ADDENDUM NO. 1

City of Spring Valley, MN
Wastewater Treatment Facility Improvements
Bid Date: October 27, 2026
Bid Time: 2:00 PM
BMI Project No. 0M2.131536

MECHANICAL PLAN BLOWER BUILDING UPPER LEVEL

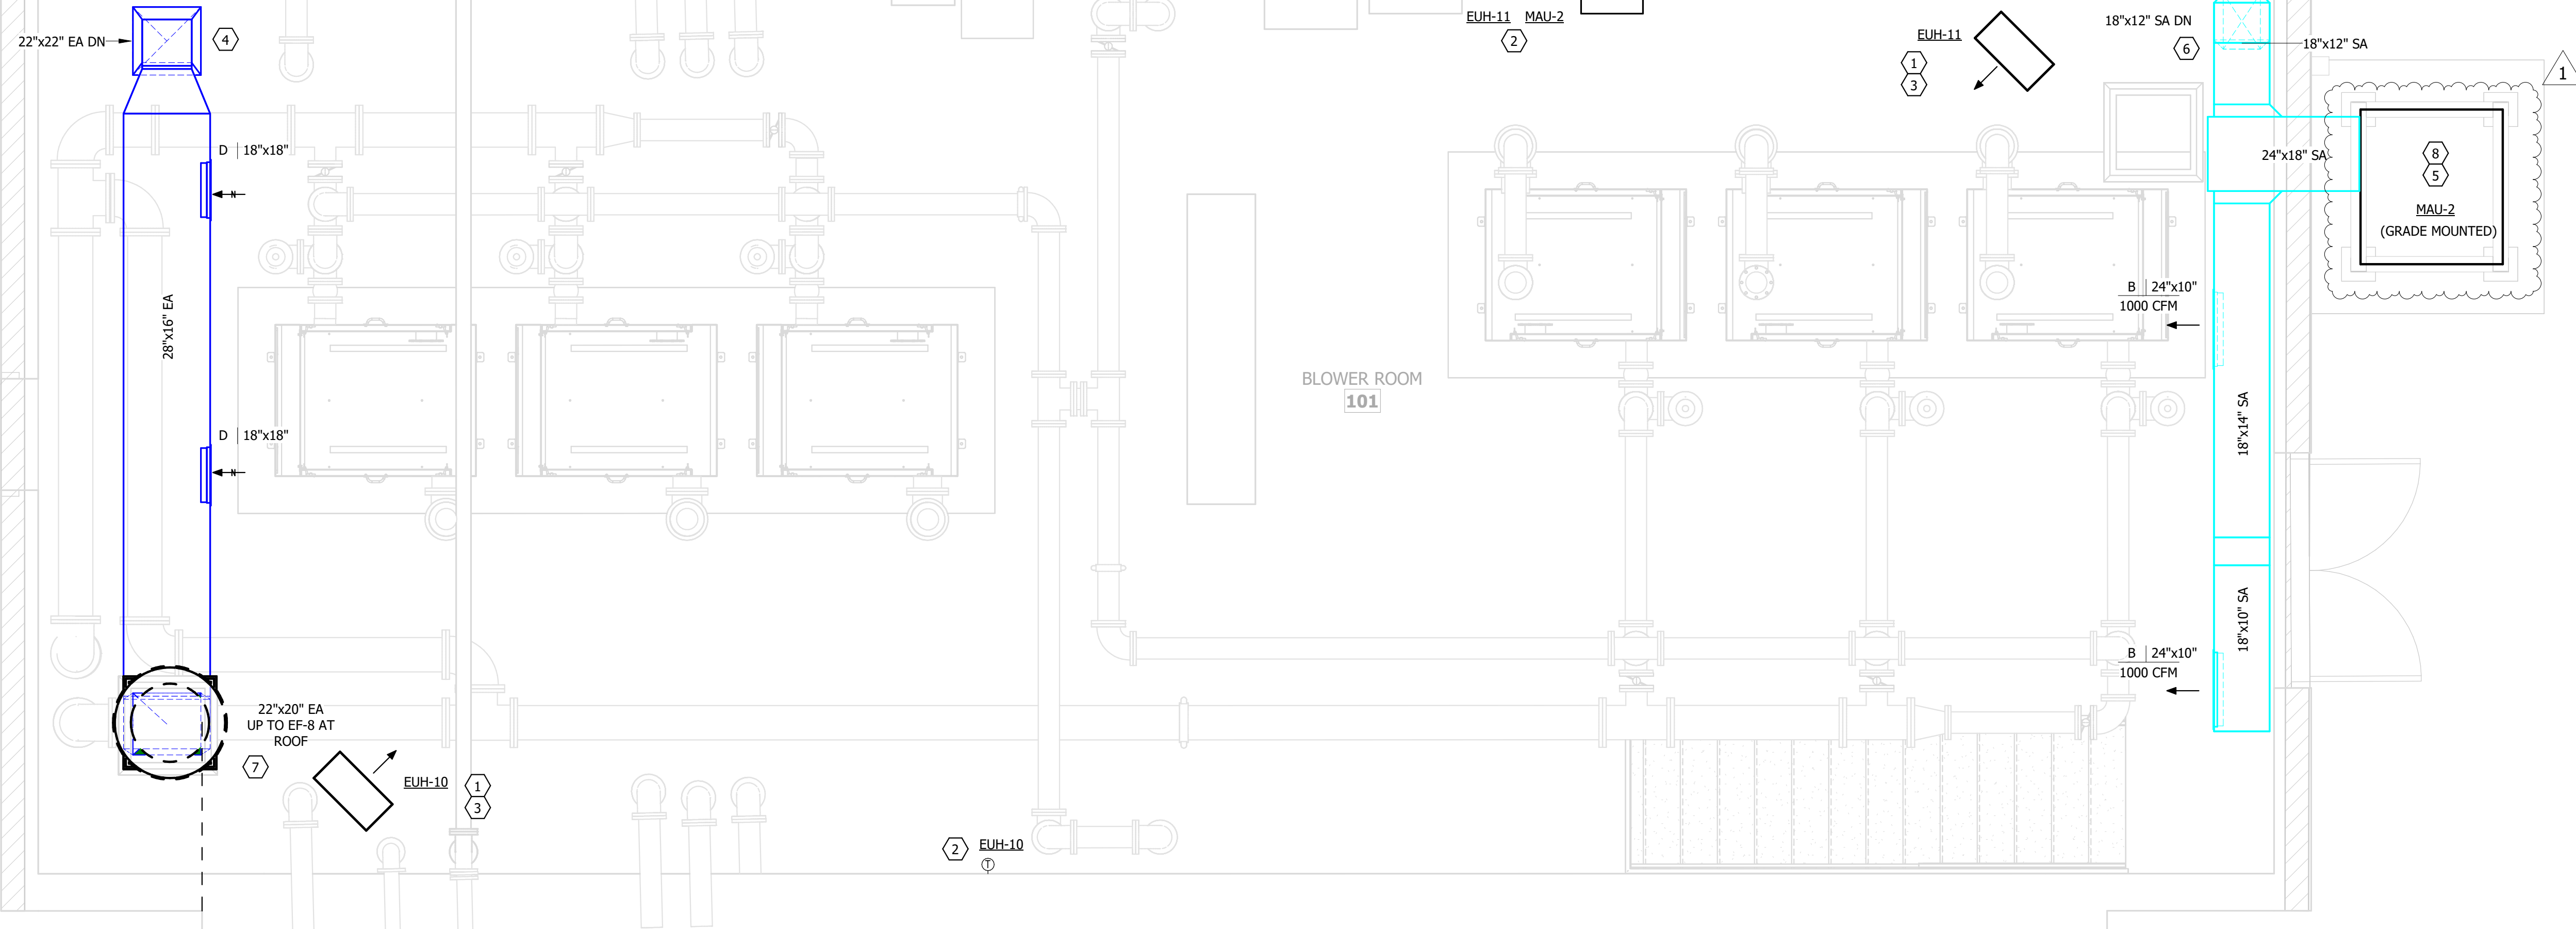
- a. Replace Sheet 6.23 Rev 0 09/29/2026 with attached Sheet 6.23 Rev 1 10/08/2026.
- b. Revised MAU-2 dimensions.
- c. Added keynote 8.

1 ELECTRICAL SITE PLAN

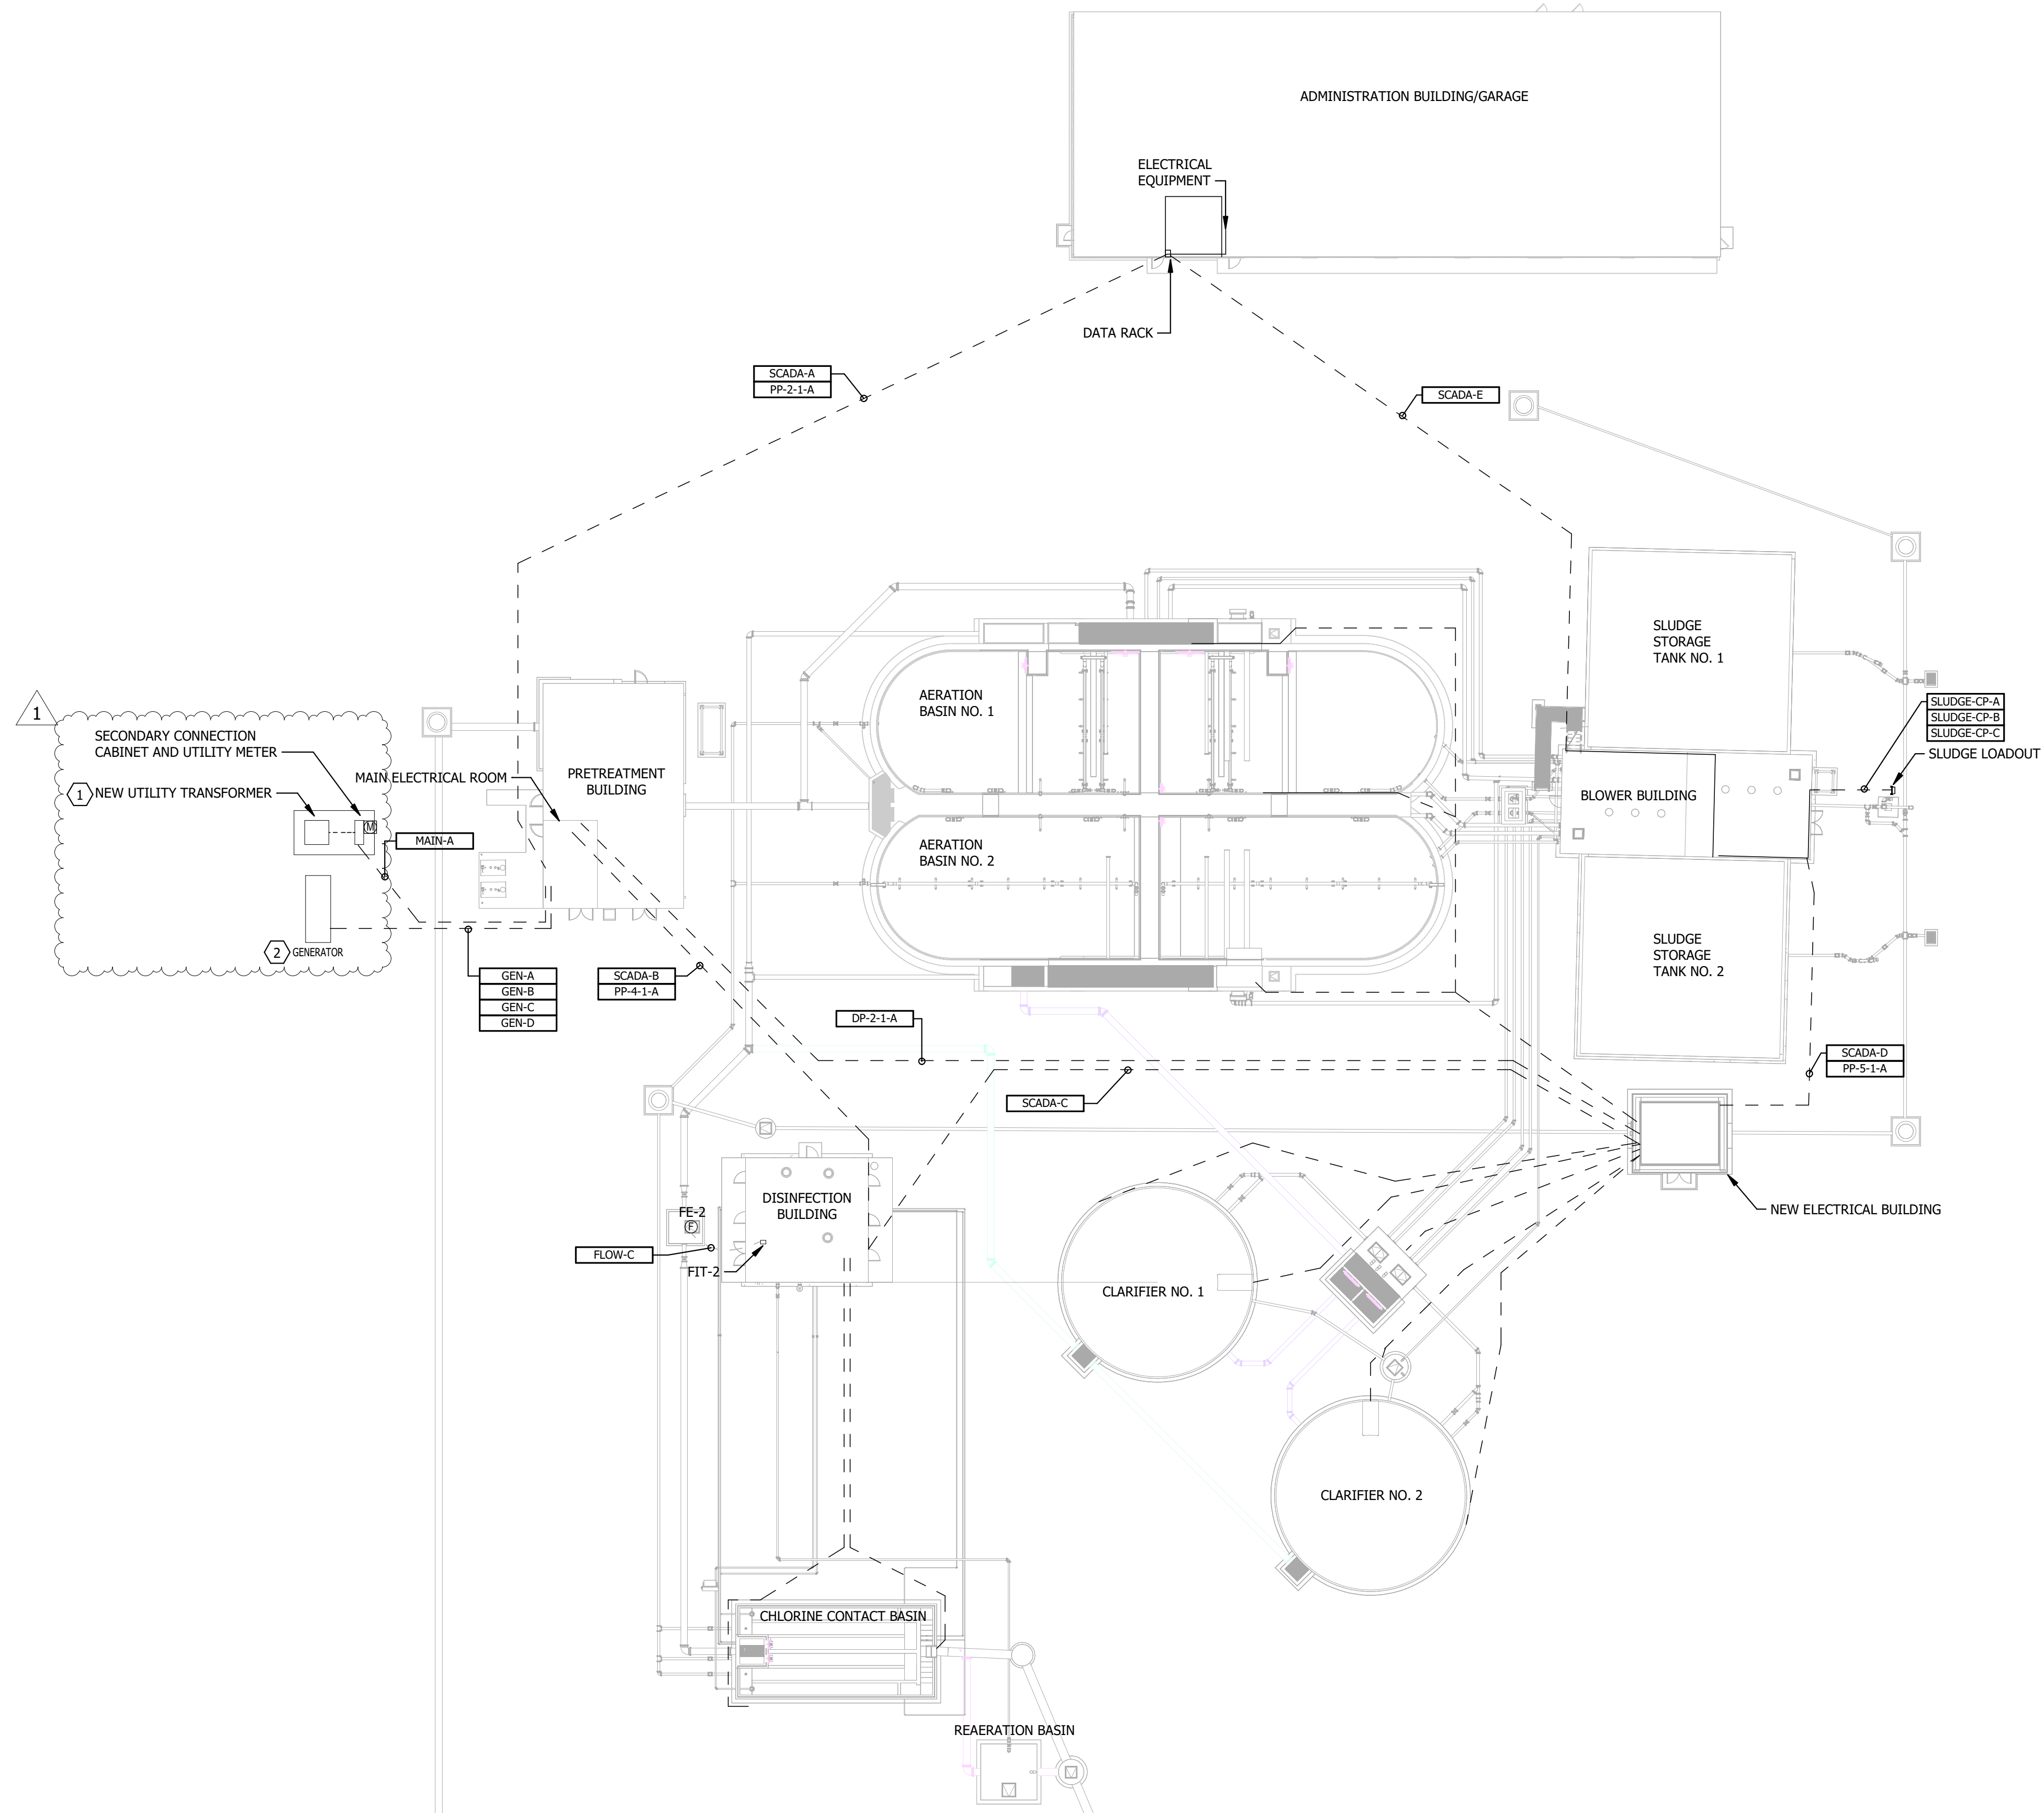
- a. Replace Sheet 7.10 Rev 0 09/29/2026 with attached Sheet 7.10 Rev 1 10/08/2026.
- b. Revise keynote #1. Contractor to coordinate final location of the transformer with the utility, provide pad-mounted secondary connection cabinet, raceways, and secondary conductors between the utility transformer and secondary connection cabinet in accordance with utility requirements.
- c. Add secondary connection cabinet.
- d. Update generator physical size.

- KEYED NOTES:**
1. CONTRACTOR TO COORDINATE FINAL LOCATION OF THE TRANSFORMER WITH THE UTILITY. PROVIDE PAD-MOUNTED SECONDARY CONNECTION CABINET, RACEWAYS, AND SECONDARY CONDUCTORS BETWEEN THE UTILITY TRANSFORMER AND SECONDARY CONNECTION CABINET IN ACCORDANCE WITH UTILITY REQUIREMENTS.
 2. COORDINATE FINAL LOCATION OF THE BACKUP GENERATOR IN FIELD. PROVIDE GENERATOR PAD AS PER MANUFACTURER REQUIREMENTS.
